**Representation of Recharge from Canal Leakage  
for Calibration of  
Eastern Snake Plain Aquifer Model Version 2**

Bryce A. Contor  
May 2008

Idaho Water Resources Research Institute Technical Report 200804  
ESPAM2 Design Document DDW-V2-01 "Canal Recharge"

Figure 9. Aberdeen-Springfield Canal loss fractions (Data courtesy Howser, 2007)

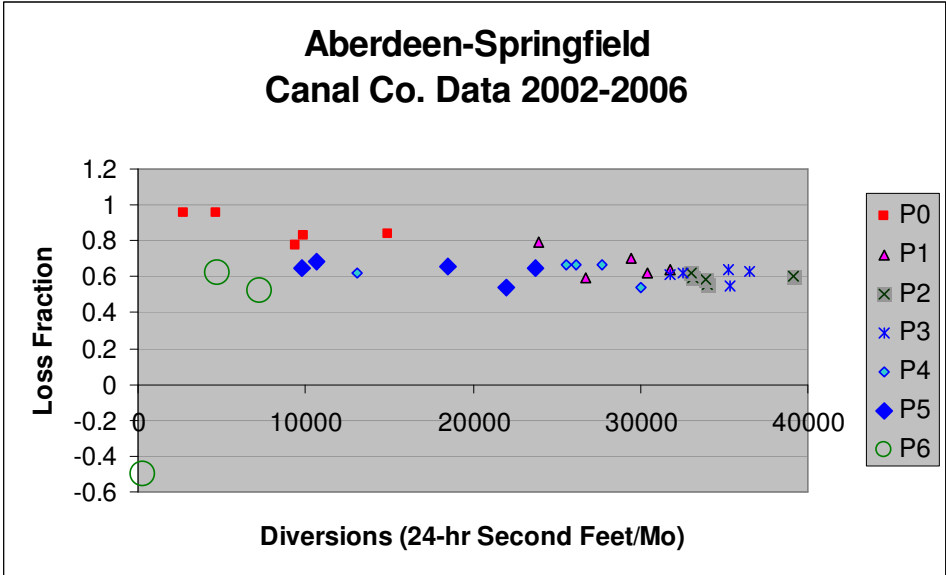
3) If I understand the plots in the PowerPoint- it seems like the semi-log plot fits Aberdeen Springfield canal better.

Note that the only significant departure from this generic equation is the Aberdeen-Springfield Canal, for which actual leakage data are available for the entire calibration period.<sup>8</sup> The generic equation gives results only slightly higher than estimates of thirty percent canal leakage obtained from managers during the two prior rounds of interviews, for other canals in the study area. It is also consistent with pre-construction estimates of losses (approximately 33%) in the Milner-Gooding canal (Gault and others, 1925) discussed above.

Parameter estimation. The current Recharge Tool allows leakage for each canal to be scaled by a multiplier, as shown in equation (1). Figure 16 shows that the operation of a multiplier would allow the generic equation to adequately represent the one canal that it initially represented poorly.<sup>9</sup>
